October 11, 2021

RE: Pedestrian Design Guidelines – September 2021 public review draft

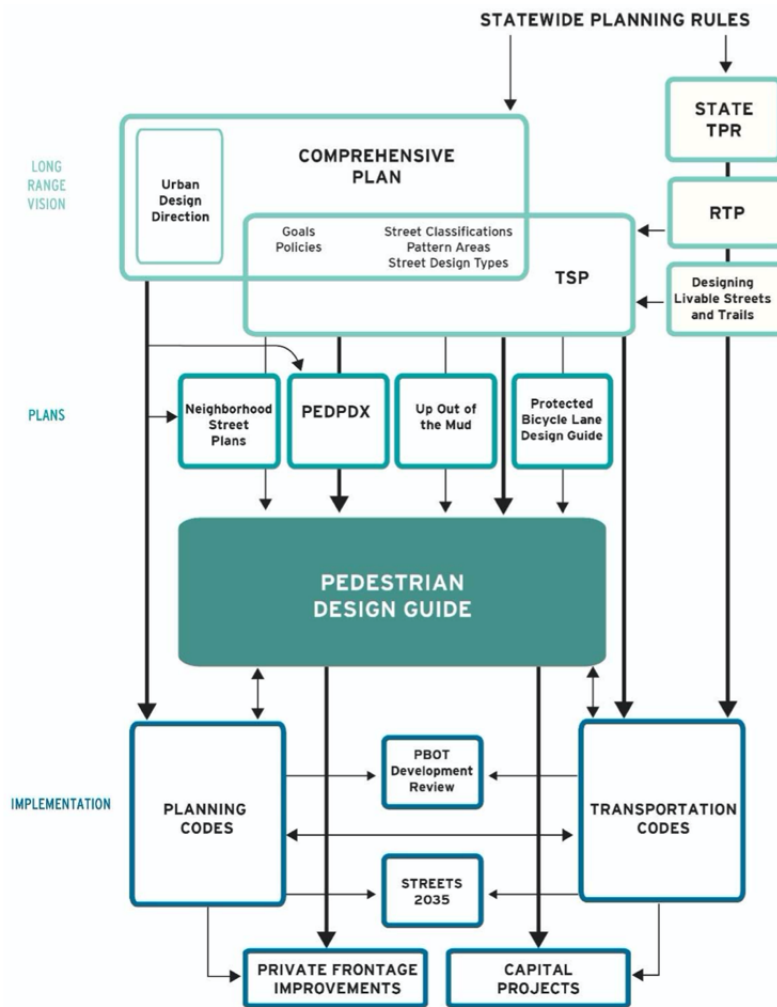
PBOT’s failure to include a proactive statement supporting trees in street ROWs stems from the incomplete Toole Design plan and policy review, which does not mention the City’s urban forest management plan, urban forestry action plan, and City-wide tree planting strategy. These omitted plans and policies define achievable urban forest canopy goals, identify tree canopy-deficient neighborhoods, and specify a mix of tree planting, care and investment strategies.

← Toole Design figure 4 showing inter-relationship of plans, visions, and implementation tools that impact the 2021 Pedestrian Design Guide. Note that, although the Metro ‘Designing Livable Streets and Trails’ guide is mentioned, there is no direct City policy/plan linking trees, tree canopy, or climate adaptation to the PDG.

The Toole Design review mentions of the Title 11 tree code, but the tree code does not identify tree canopy goals or define how the City will meet those goals. As a result, the conclusions of the PDG plan and policy review leaves out any acknowledgment and accommodation of the City’s needs to preserve and expand urban tree canopy. This is a glaring omission because street right-of-ways (ROWs) are a large percentage of public space within the City where additional tree planting and maintenance is needed to meet our Climate Action Plan goals. By including these higher-level City tree plans and goals, the PDG could properly frame the challenges of space-constrained pedestrian

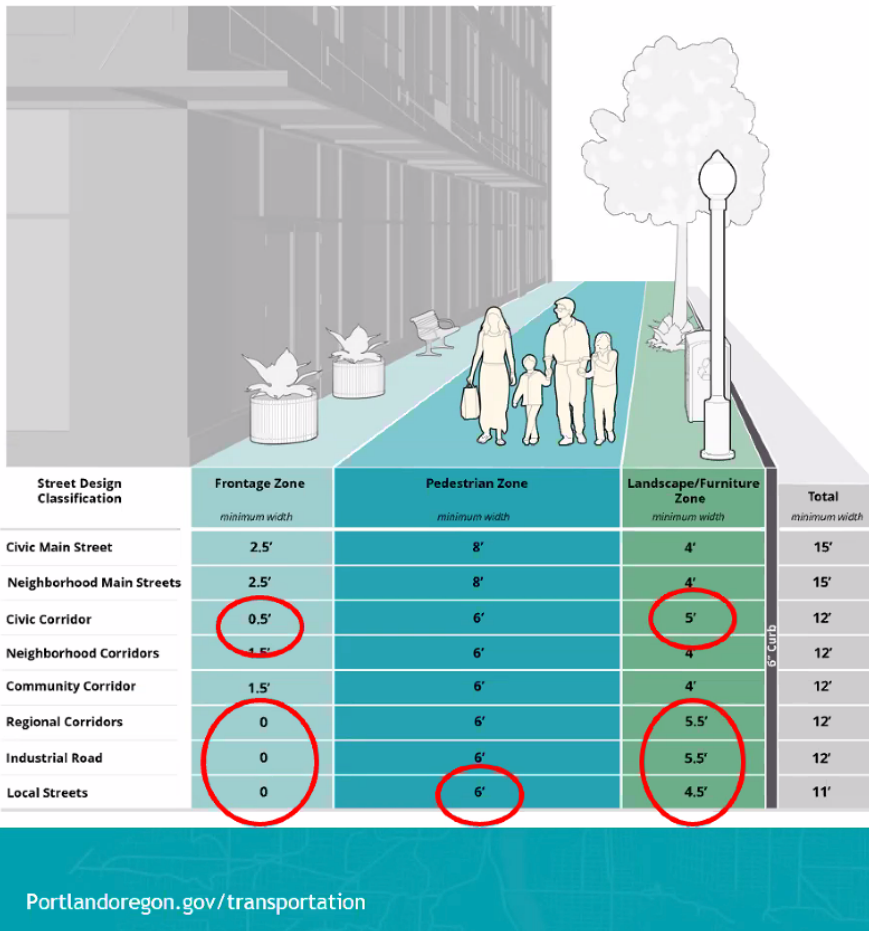
An earlier draft Table B-3 from October 2020 that we reviewed in the stakeholder advisory meetings had proposed 0-foot frontage zones along local streets, industrial roads, and regional corridors to make room for minimum furnishing zones widths of 4.5 to 5.5 feet. Please reconsider an allowance for letting the frontage zone shrink to 0-foot width in space-constrained circumstances (at least along Local Streets) where additional furnishing zone width is needed for trees and other public infrastructure/needs. This approach may not be feasible in all circumstances but should be allowed by right where appropriate.

October 2020 DRAFT Pedestrian Design Guide Table B-3 showing instances where frontage zone widths were narrowed or eliminated to expand landscape/furnishing zone widths. In the October 2020 draft PDG, along Civic Corridors, Regional Corridors, Industrial Roads and Local Streets the frontage zone was narrower than what is proposed under the September 2020 PDG to accommodate slightly larger furnishing zones.
